Workshop Dobby Loom Raddle Placement

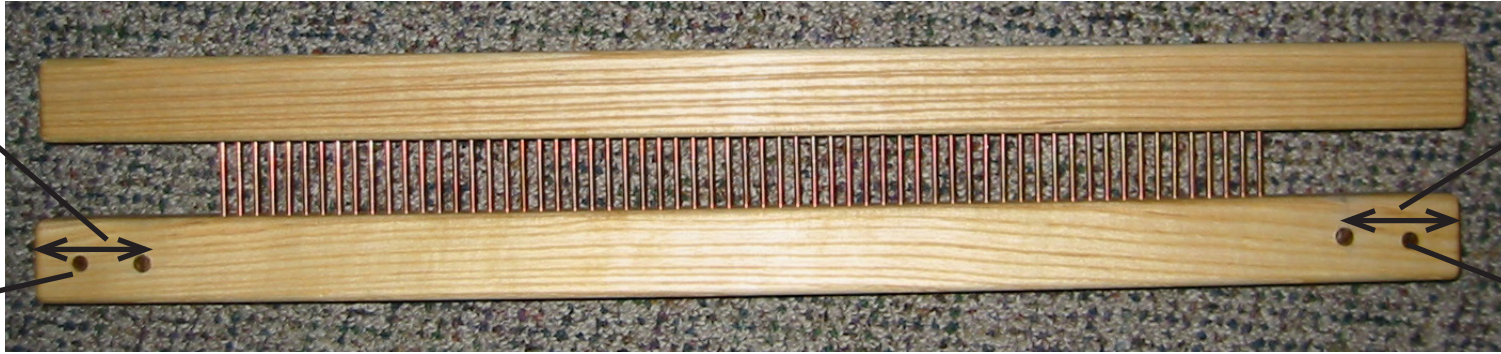
Note: Holes for metal rod should be $\frac{1}{4}$ " and not $\frac{17}{64}$ "

New Hole
centered
 $1\frac{3}{4}$ "
from end
of raddle

New Hole
centered
 $1\frac{3}{4}$ "
from end
of raddle

Hole centered $6\frac{7}{8}$ "
from end of castle

Hole
centered
 $1\frac{3}{4}$ "
from end
of castle
